DOCUMENT 00 90 00
ADDENDUM

ADDENDUM NO. [1] **Date: January 30, 2020**

RE: **WITC – RICE LAKE CAMPUS**
PARKING AND SIGNAGE
1900 COLLEGE DRIVE
RICE LAKE, WI
HSR PROJECT NO. 19023-3

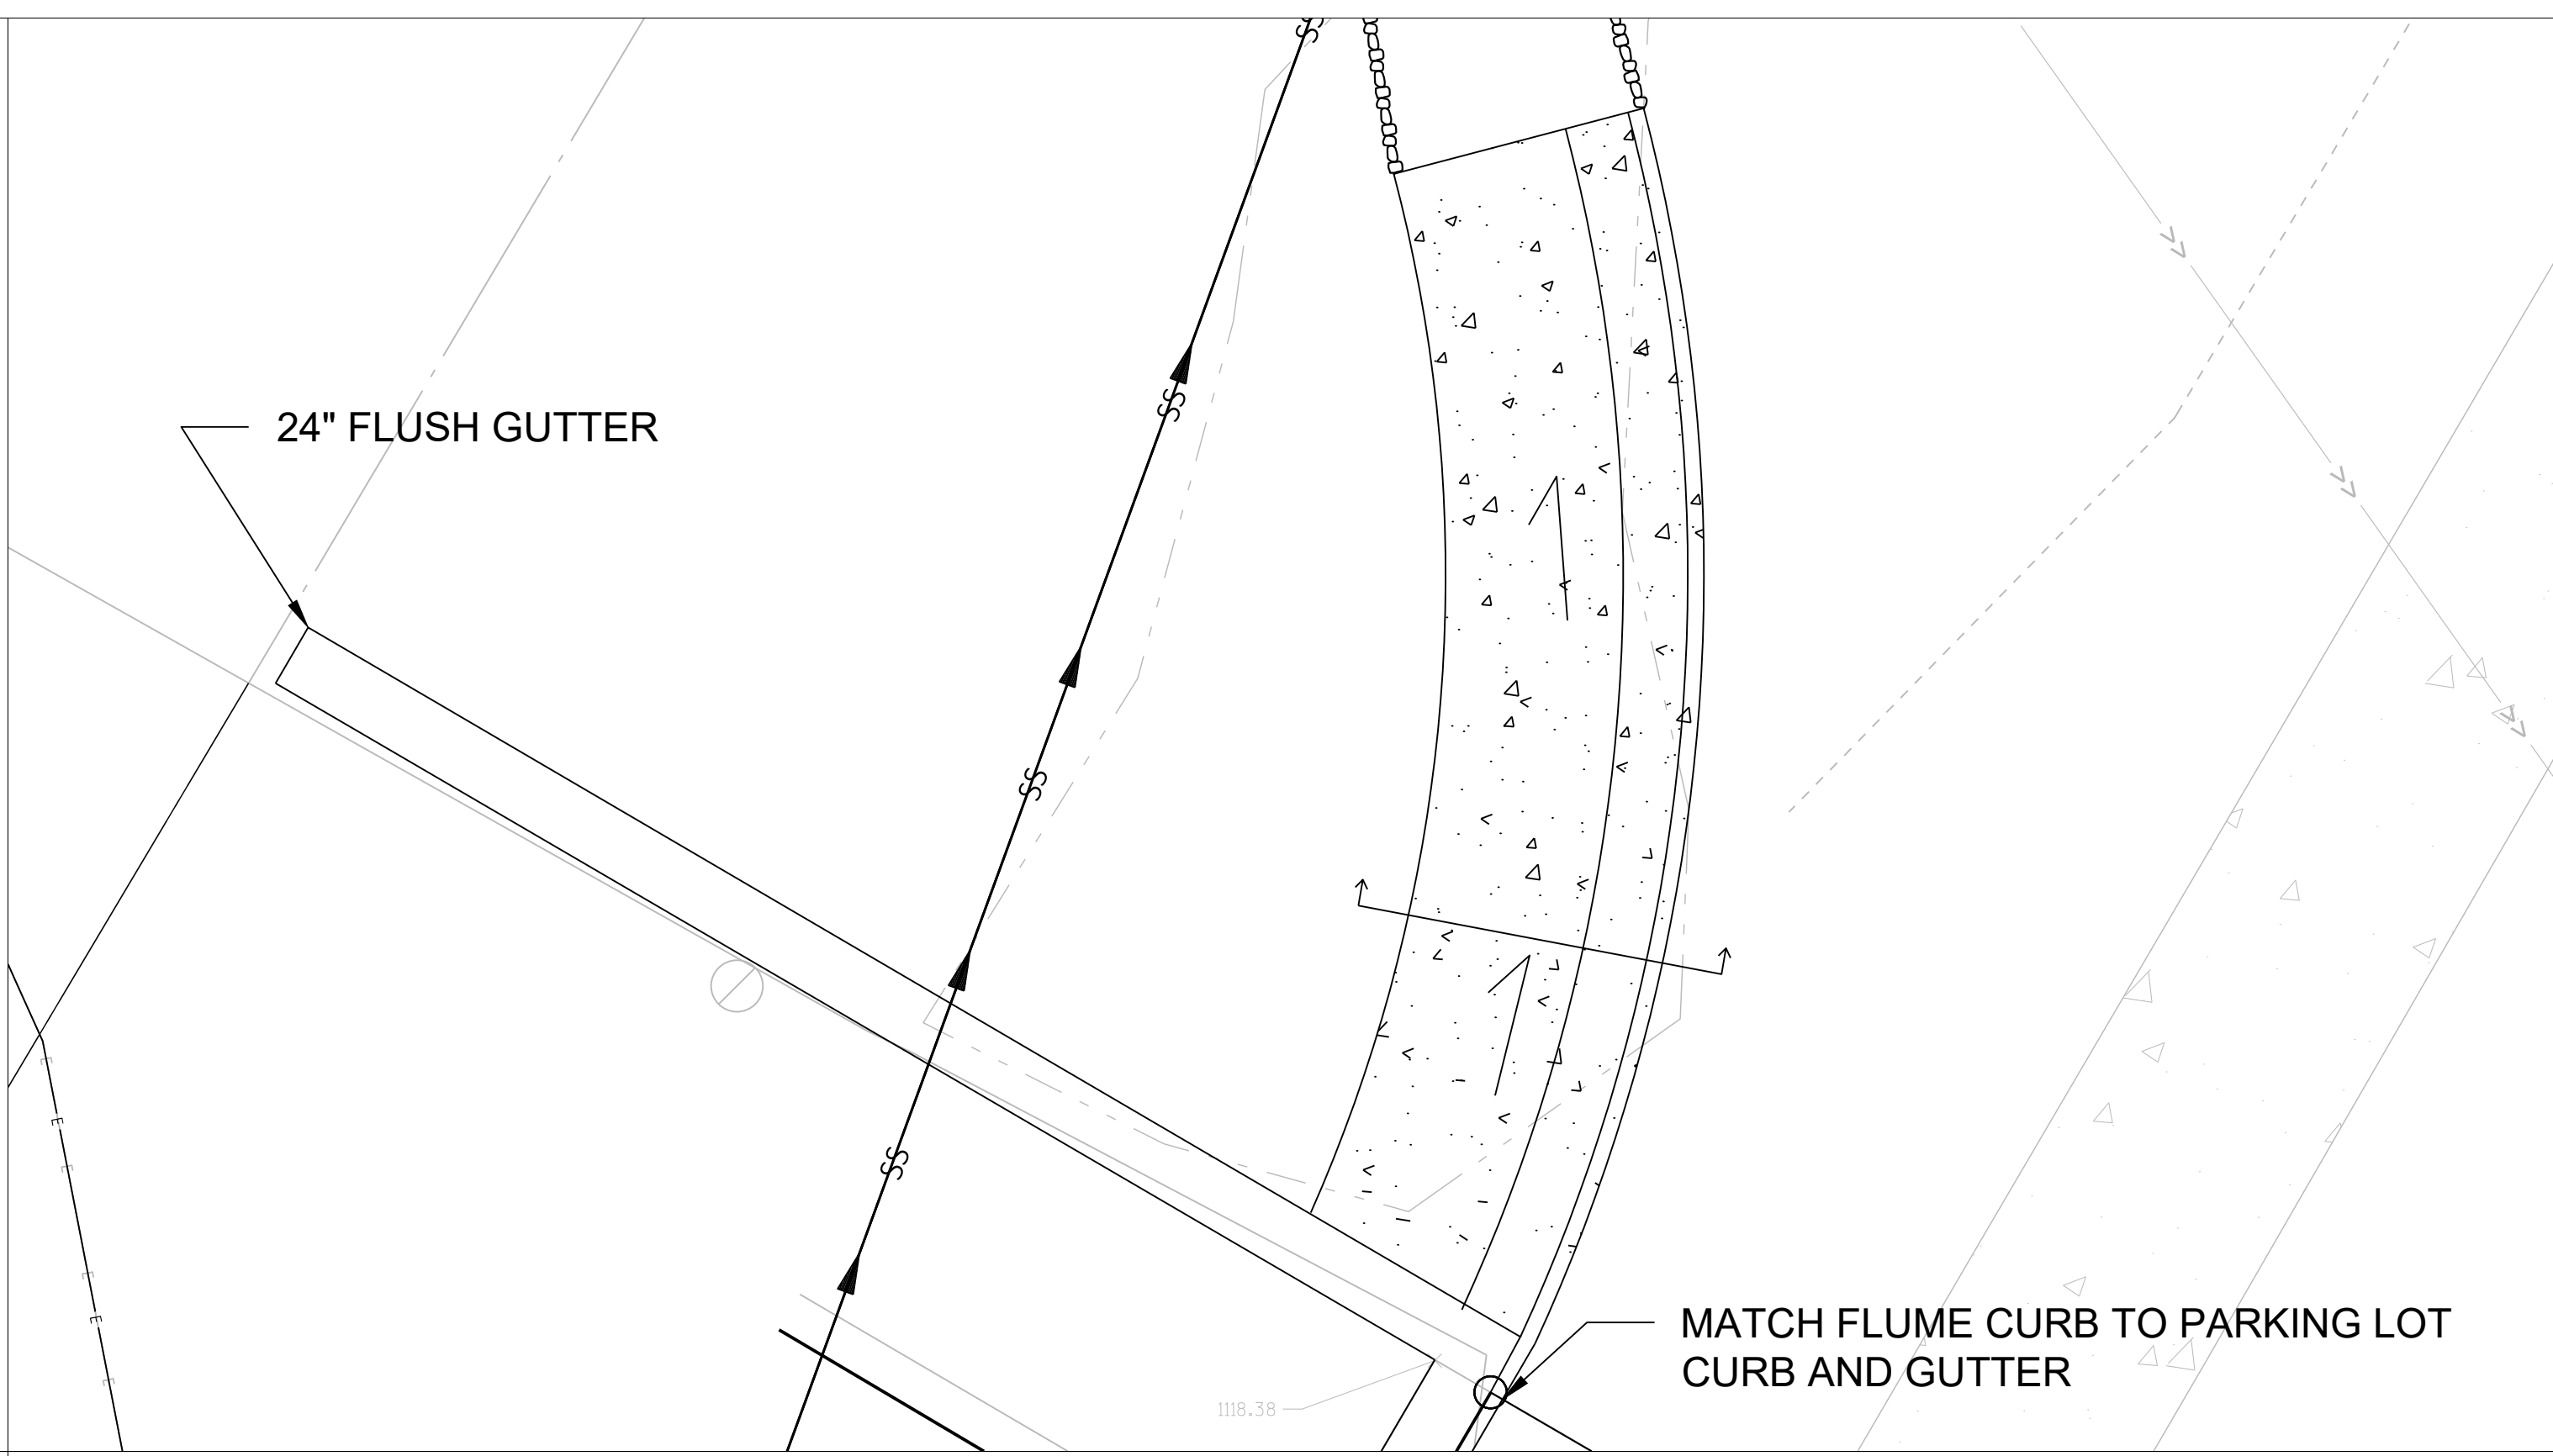
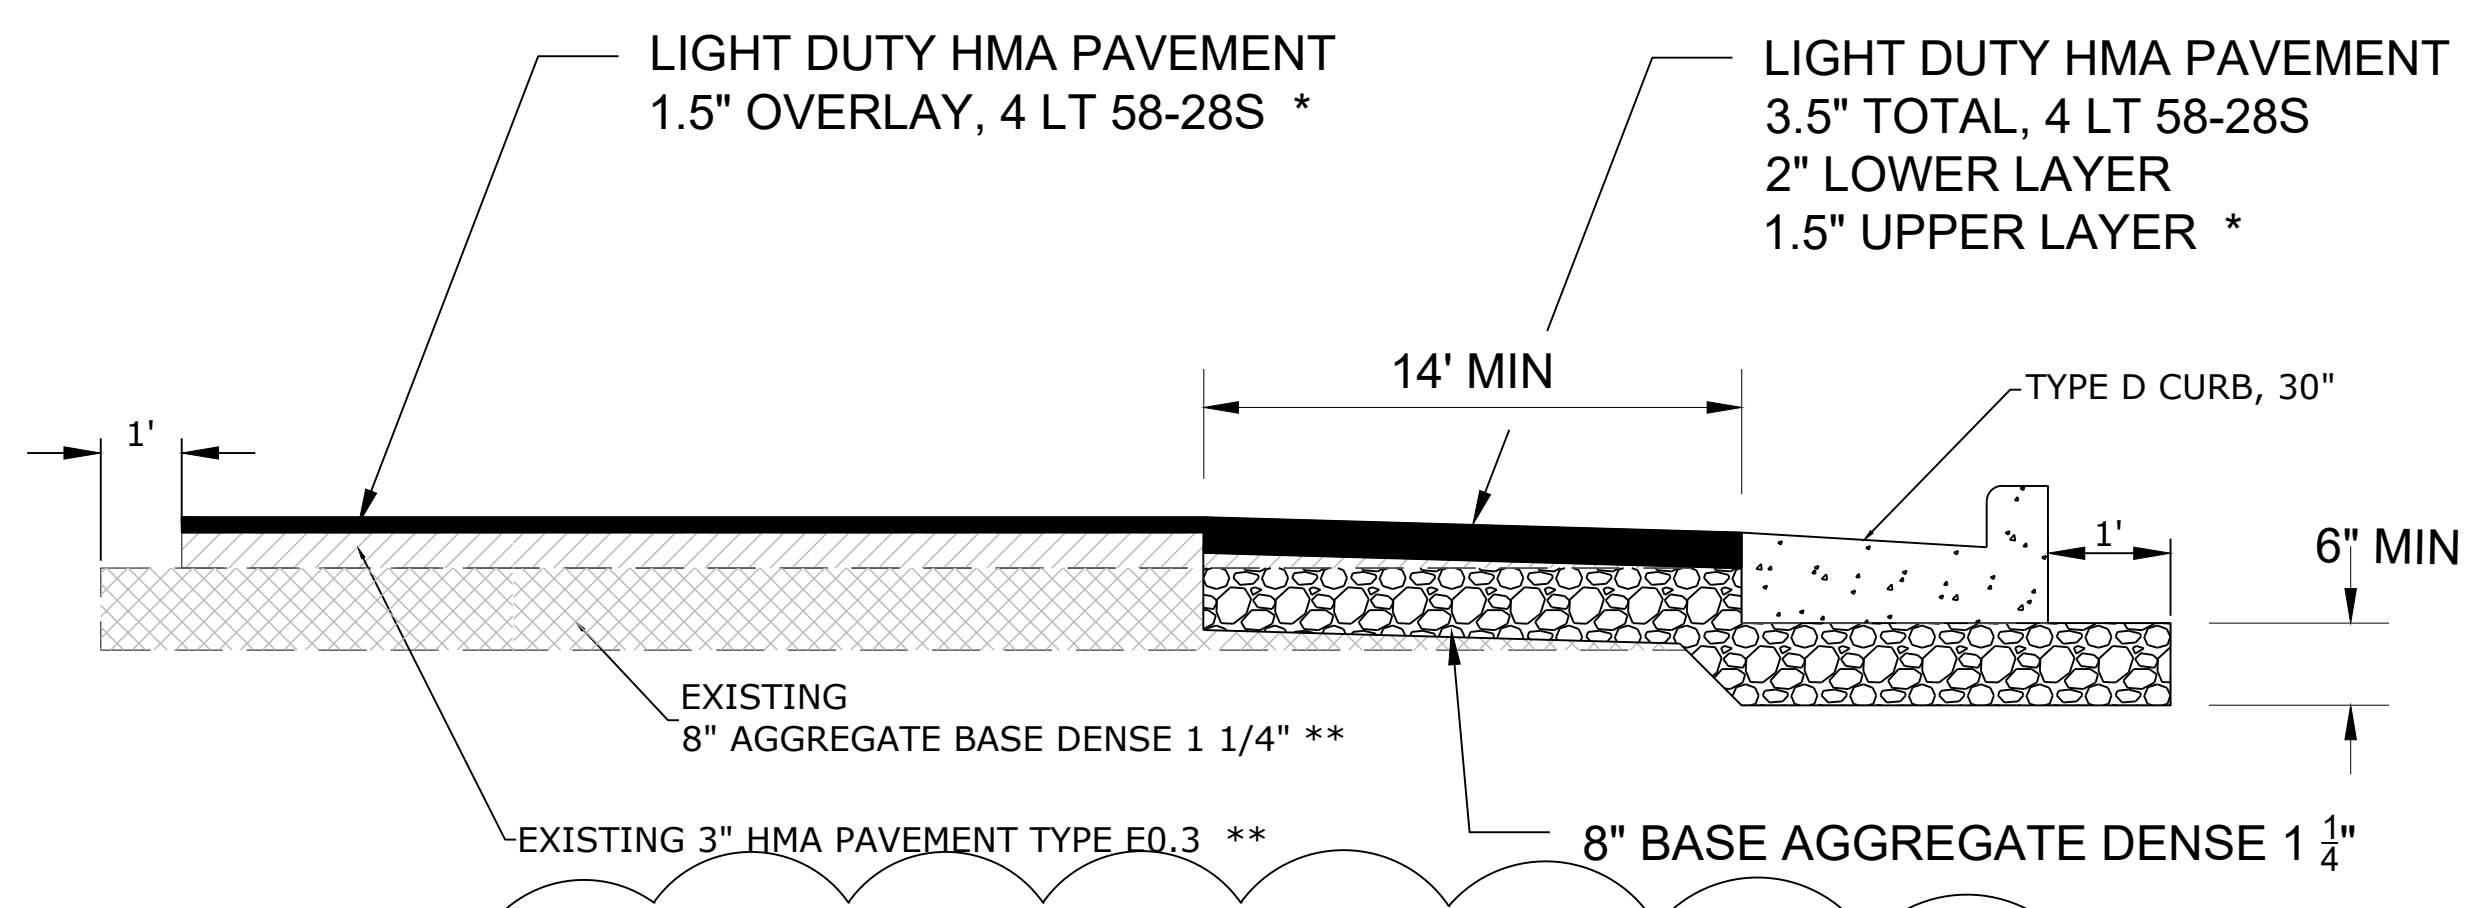
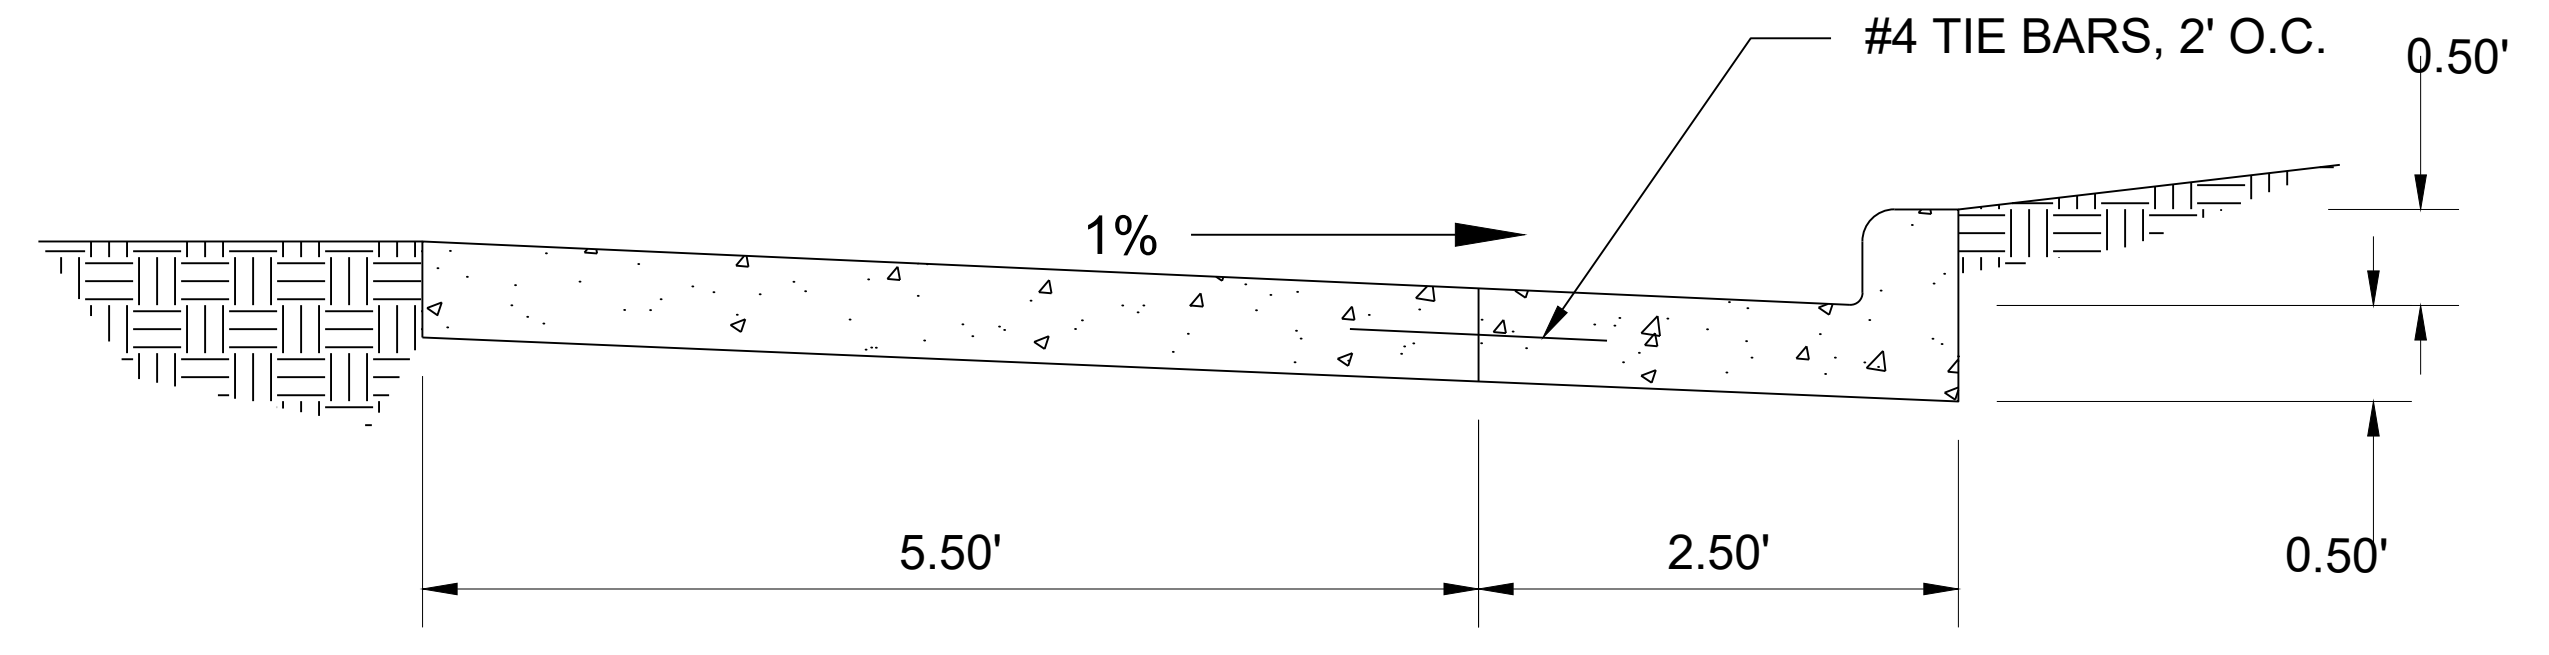
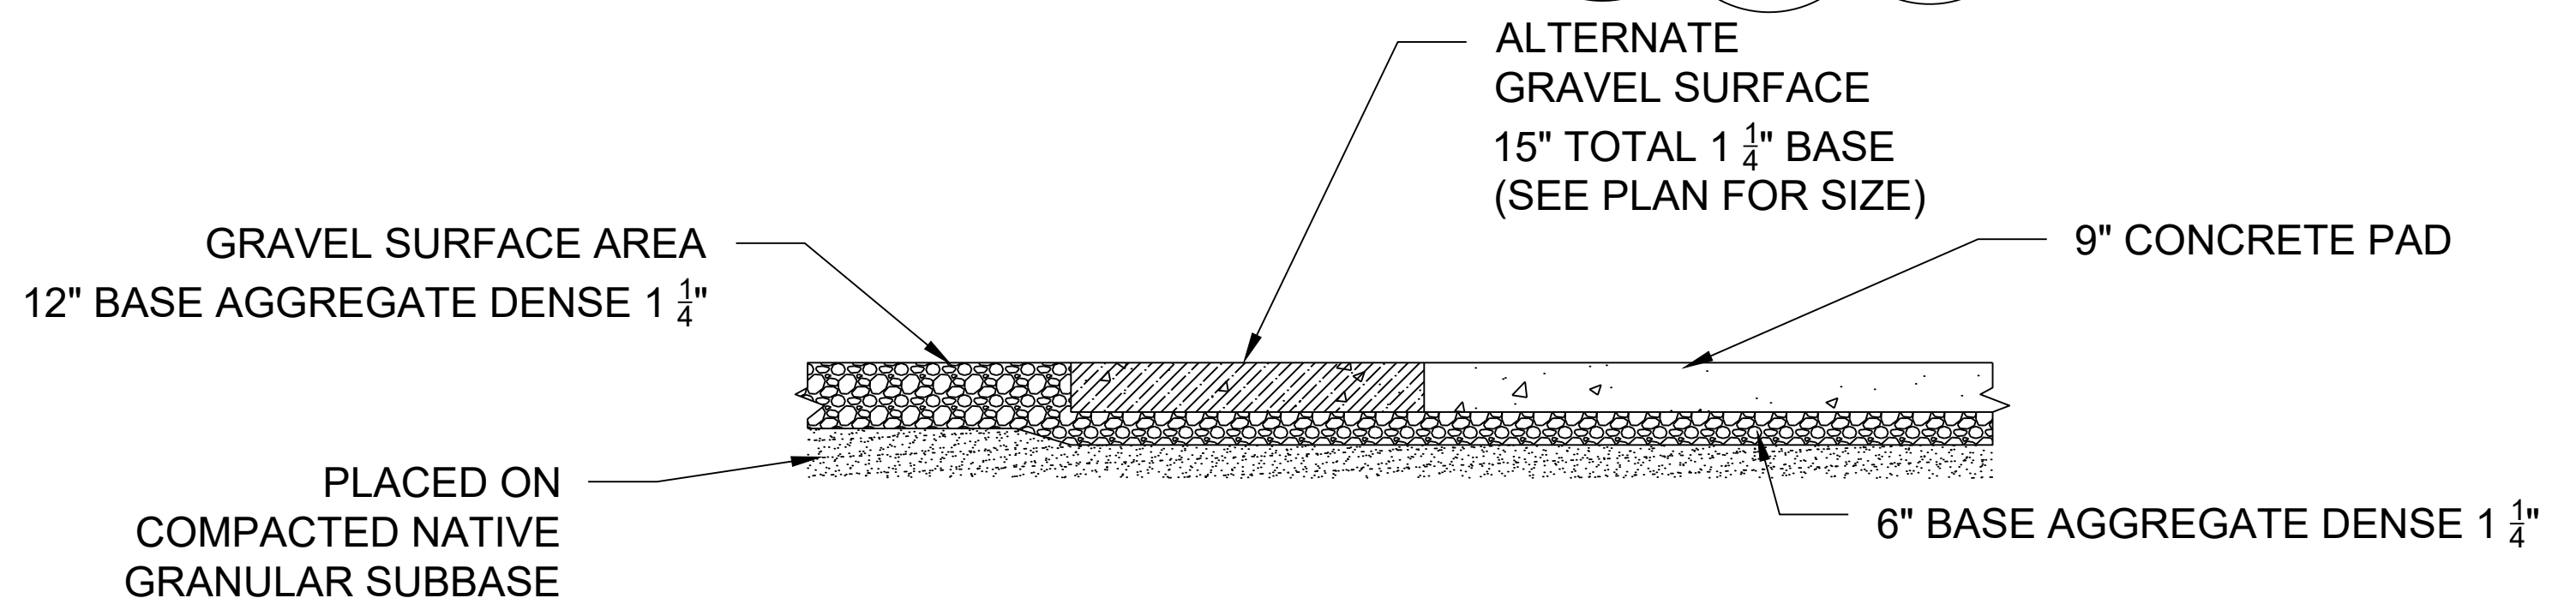
12. C7 DETAILS 24 x 36 attached hereto
 - a. Revisions clouded on Drawing.
13. C9 DETAILS 24 x 36 attached hereto
 - a. Revisions clouded on Drawing.

** FROM PAST PROJECT RECORDS
* THE AIR VOIDS REGRESSION PER WISDOT WILL NOT APPLY TO ASPHALT PAVEMENT

* THE AIR VOIDS REGRESSION PER WISDOT WILL NOT APPLY TO ASPHALT PAVEMENT
